SCI-823-0.00

US 52 RAMP B OVER US 52 AND OHIO RIVER RD

PRELIMINARY DESIGN REPORT SUBMITTAL

**SUBJECT: Preliminary Design Report Submittal
US 52 Ramp B over U.S. 52 and Ohio River Road (CR 503)
SCI-823-0.00 Portsmouth Bypass
PID#77366**

SITE PLAN
 SCI-823-0.00
 PID 77366

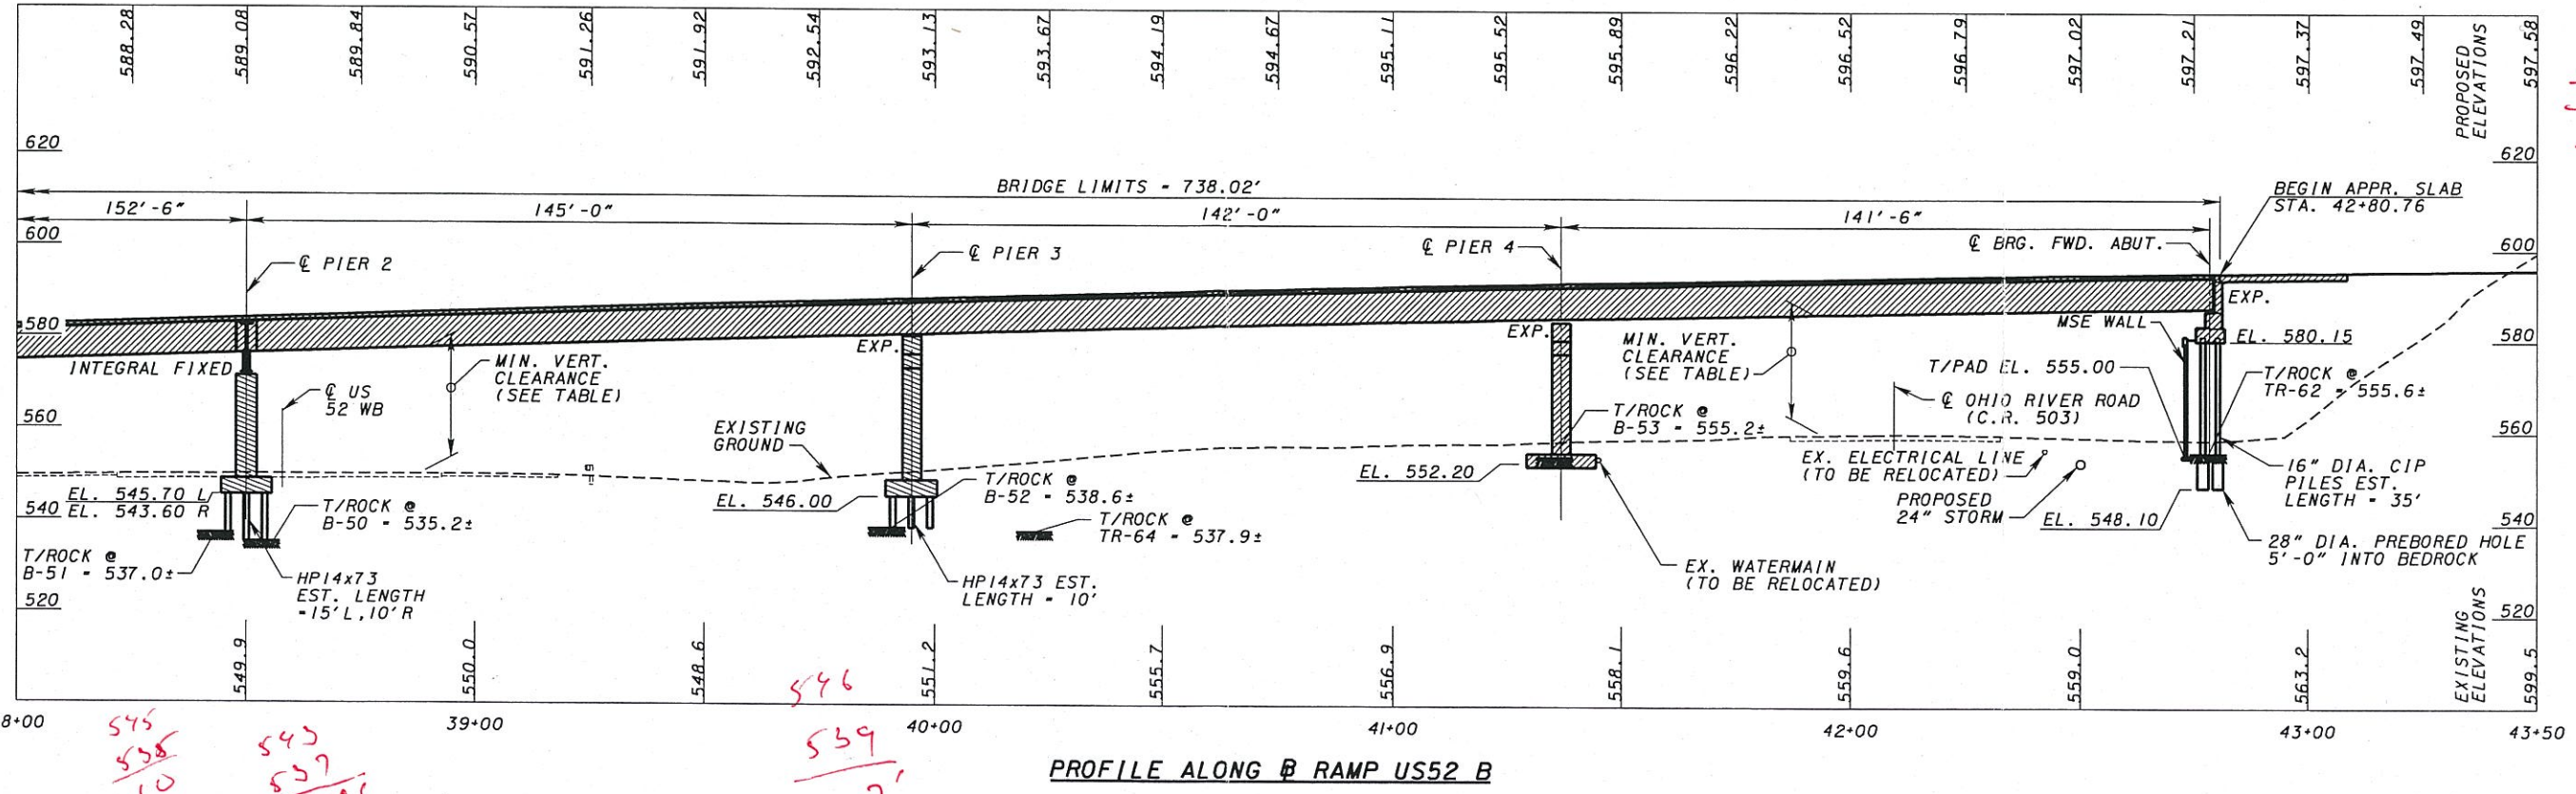
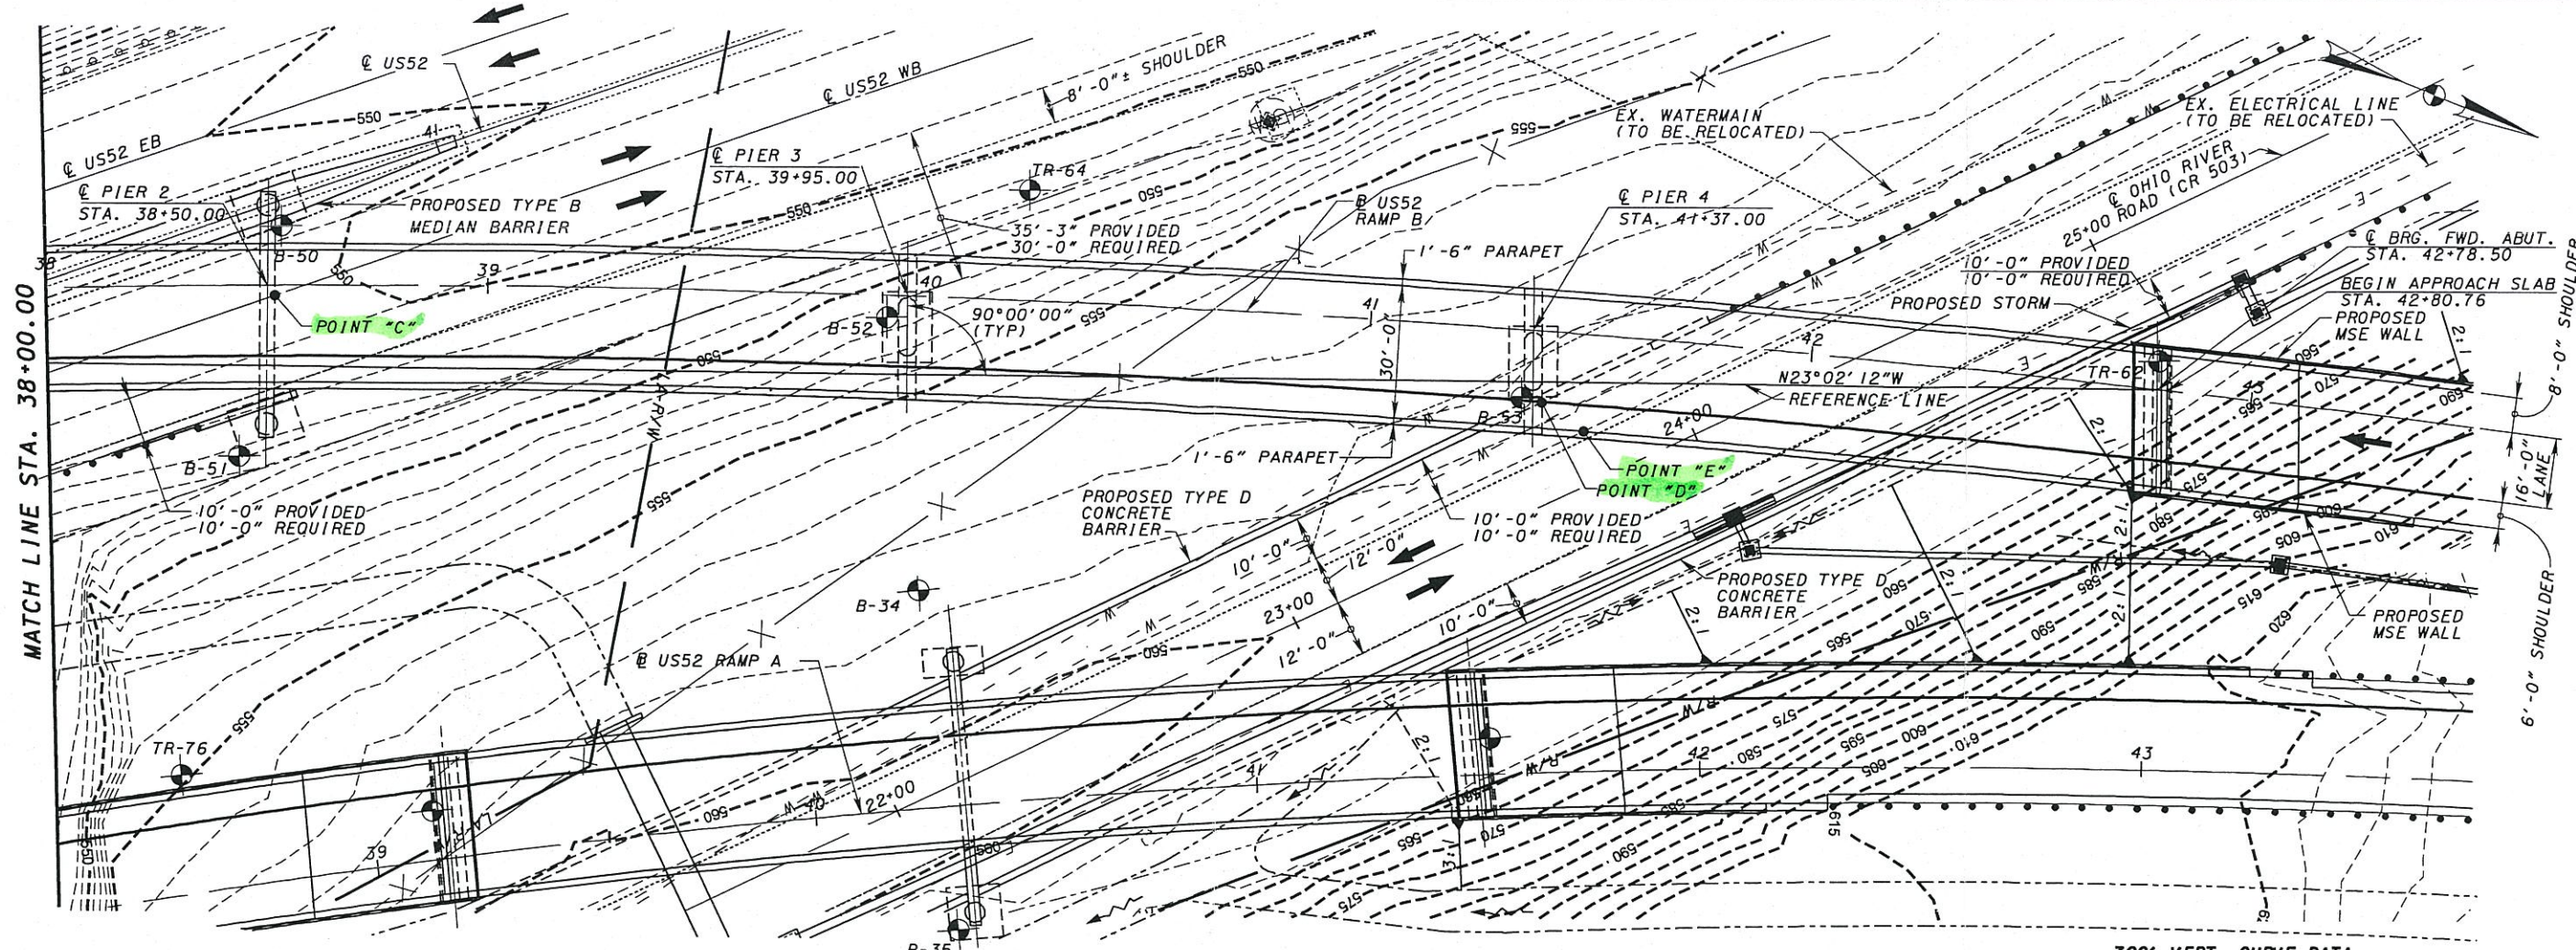
show scupper

MSE WALL SCHEMATIC PLAN - WALL NO. 3
 BRIDGE NO. SCI-823-0067L
 US52 RAMP B OVER US52 AND CR503 (OHIO RIVER ROAD)

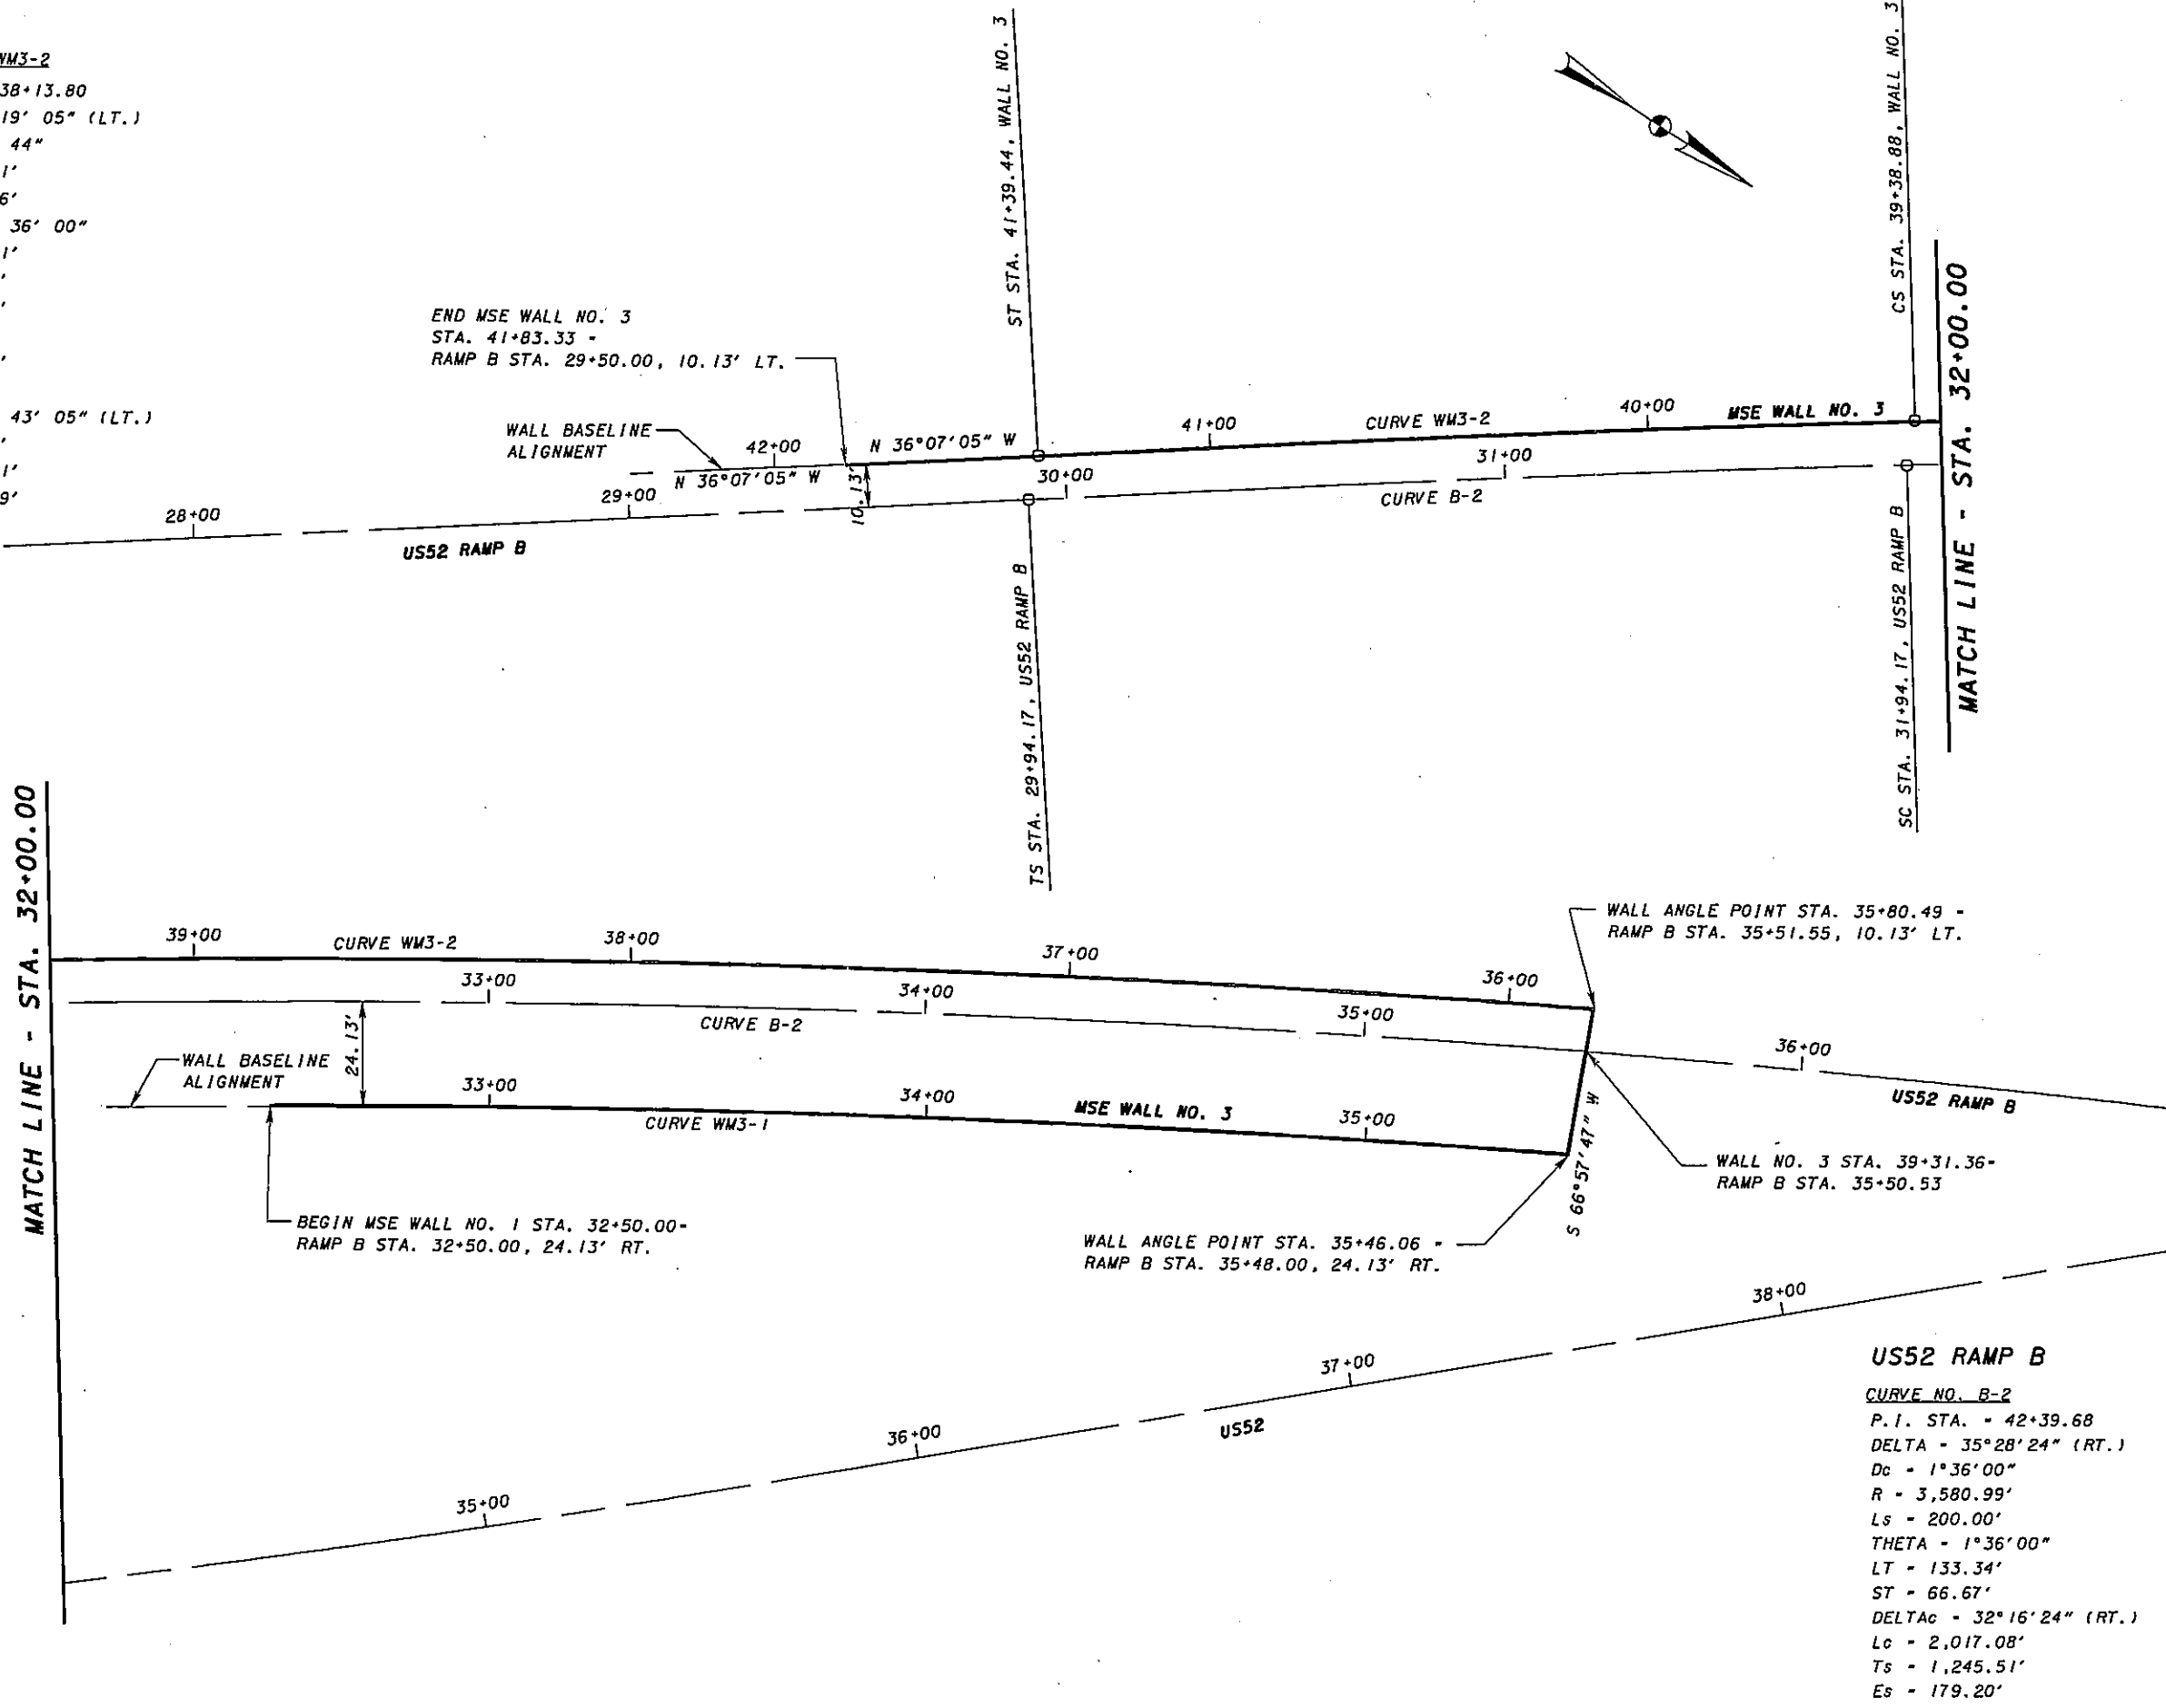
Block cost for MSE wall
